TITLE: BigTime-v13		SFE	SFE
Document Number:			REV:
Date: not saved!			Sheet: 1/1

Based on Solder:Time, ClockIt, and Serial 7-Segment

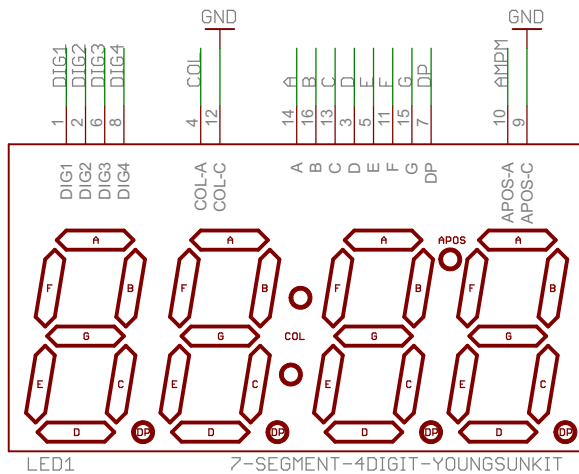
Changes to v11:
 Swap TX/RX
 Silk Update
 Tented the one via
 Increased R1 to 100k

Changes to v12 (1/6/12 MH/PL):
 updated package on 7-seg display
 updated package on ATMEGA328

Changes to v13 (4/26/12 PL):
 updated package on Coin Cell
 Added polygon pours around pads on coin cell connector to prevent pulling pads during assembly
 Moved SFE logo to avoid clipping
